Access Compliance Report

Public Rights-of-Way

(Curb Ramps)

Intersection ID: 10016341	Main Street: UNIVERSITY_CITY_BV	Cross Street: N/A	Location: NE
ADA ID: CBB59C771DED	Ramp Type: Directional1	Initial Pass/Fail: Fail	Overall Compliance: No
Severity Score: 1.25			
Codes/Mitigation Info/Possible Solution		Field Measurements/Component Compliance

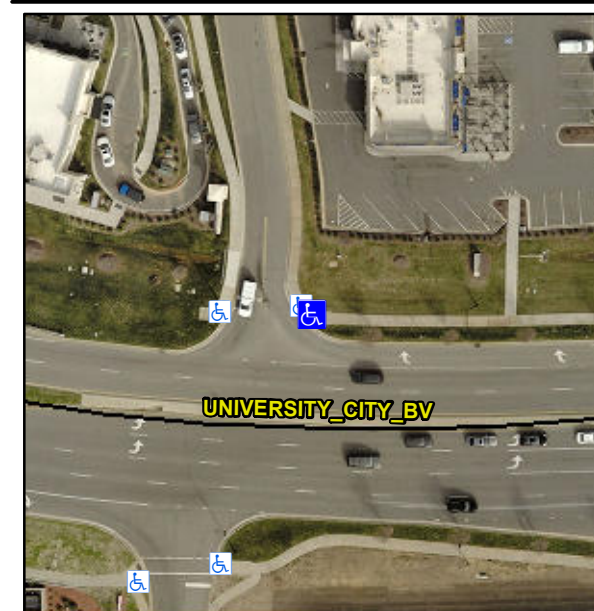
Remove & Replace Entire Ramp.

R304.5.3
